Burlington Walk Bike Council (BWBC)

January 3rd, 2023 Meeting Notes

2. Winooski Bridge Replacement Design Project

Presentation from Steve Spear (HNTB) on Current Alternatives under consideration

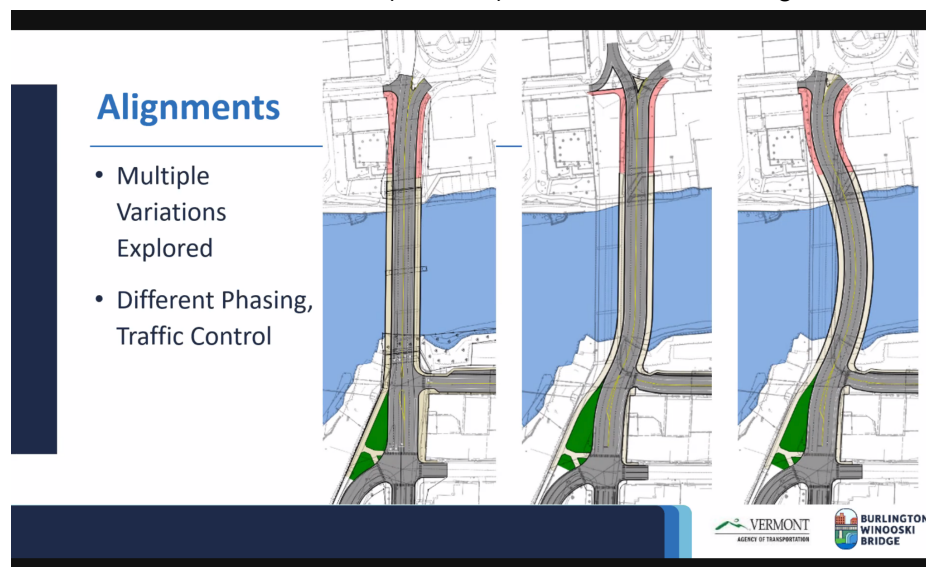
Bob - Likes the roundabout on Shelburne Rd (made by VTrans), designed and built for 20K vehicles but now only handles 15K. Based on that reduced use, why are we building for high-traffic 2 lanes instead of 1 lane? Do we anticipate increased demand?

Bob - After confirming that only a 2-lane circle was evaluated, asked why couldn't there be a 1-lane circle in that location?

Jason - Curious as to why 2-lanes are prioritized when much of the traffic coming into the intersection is 1-lane. It increases the conflict points and 2 lanes don't necessarily make things safer or easier. We should evaluate traffic throughput in that location again.

Peter - The project is not sensible in the way that funding is determining design. The project doesn't fit current needs. It seems anachronistic to cling to old traffic projections for motor vehicles. The existing bridge is structurally sufficient and doesn't need to be updated until we have a better plan. Could use congestion pricing to reduce traffic volume. Removing signals is a proven way to reduce traffic volume. Through traffic should be directed to I-89 instead of this area. Reasonable to have 1 lane each way plus bikes and pedestrians on existing bridge. Curious as to what steps are necessary to cancel the project.

Evan - The vast majority of comments at prior public meetings were regarding walk/bike so why hasn't the design been updated to incorporate all that feedback?

Evan - We know wider lanes increase traffic fatality rates and speed. Why should those be considered?

Evan - The fundamental bridge design doesn't fix any issues. Can this project be canceled?

Jak - Wanted to echo some previous points. Widening of the lanes doesn't seem to be as necessary as is claimed. VTrans standards require 11-12' lanes on arterials where the speed limit is 50-65 mph, but on the Winooski bridge it will only be 25 mph so should design for that. Wider lanes means higher speeds. This whole project is treating anything other than car traffic as an afterthought. The current sidewalk on the bridge is really bad now so we need the separated pedestrian/biking infrastructure. It will be most safe when bikes and ped are separate and motor vehicle speeds are low. Question: What dictates the vehicle lane width here, and why is it always getting bigger?

Jak - If the current bridge is structurally sufficient why can't we experiment with reducing the amount of lanes and expanding the multi-used paths?

Charleen - Concerned about speeds because of wider lane widths. Would the "curved" alternative slow down lane speeds in a noticeable way?

Jason - The middle alignment option could handle extra bike/ped construction. Is there a limit to bridge width?

Steve - A roundabout was considered in the scoping phase, but the site constraints (space to river and cliffside and historic nature) would have right-of-way impacts that kept it from being selected.

Steve - It was determined that going down to single-lane isn't feasible from a traffic design standpoint. He understands their concern but they are building for existing and anticipated future traffic demand.

Laura - These choices were made in 2017 and we are ultimately held to those choices. The Shelburne Rd roundabout is currently not congested because the city is devoid of office workers now, which is a completely different problem. With the combination of Colchester and Riverside on one side and Route 2 and Route 15 coming together on the other, it's essentially like a 4 lane highway that is necessary to move the traffic through the location.

Bob Klinefelter (VTrans) - There is a hard funding date for the bridge project. Need to get the June contract out by June 2026 or the funding goes away. Speaking to the bridge project's 4 lanes, it is being built for a 100 years of use, but wants to clarify that the space need not be allocated for cars ad-infinity - can reallocate space later. The intersection was originally

Michael LaCroix (VTrans) - We can't change scope at this point because of the way the project is funded. The intersection is built with future traffic in mind. The Shelburne St. roundabout was built with room for expansion to 2 lanes if needed in the future. If we were to build a single-lane roundabout at CoBaRi we would still need to allow for expansion to 2 lanes, with the same impact on surrounding properties, and the land would need to be acquired for that purpose.

Laura - In response to the questions "is the bridge structurally sufficient," the bridge isn't at immediate risk of falling apart, but it is in need of structural improvements. There is no difference in structural needs for 2 lanes versus 2 lanes. The reconstruction is intended to handle expanded ped/bike/motor traffic. In response to whether the rest of the network can handle the traffic on the bridge, the team is going to look into this as part of the plan to close the bridge for construction.

Josh - The walk-bike lanes are being increased dramatically. The expansion of vehicle lanes is mostly to handle the additional buffer needed on the edges due to the safety barrier.

Laura - the 11 foot lane is a state standard. They are considering asking for a waiver but large vehicles like buses and ambulances are 10.5 feet wide at mirrors so can't be next to each other. Still would need a buffer on the edge even if lane widths were reduced.

Laura - The bridge isn't falling down but it is near the end of its life. It may not survive another 20 years without significant maintenance.

Josh - All the alignment alternatives are being considered. Traffic calming *could* be a benefit but the curved alignments aren't being considered strictly for traffic calming.

Bob K - The curved alignments might be able to include bike-ped facilities under the bridge, though it will likely be more expensive.

Laura - There is a cost to every trade-off. Something like that could be a good future project, but funding isn't unlimited and ultimately most of it comes from the feds. The curved alignments work well on the Burlington side but would require taking more land on the Winooski side.
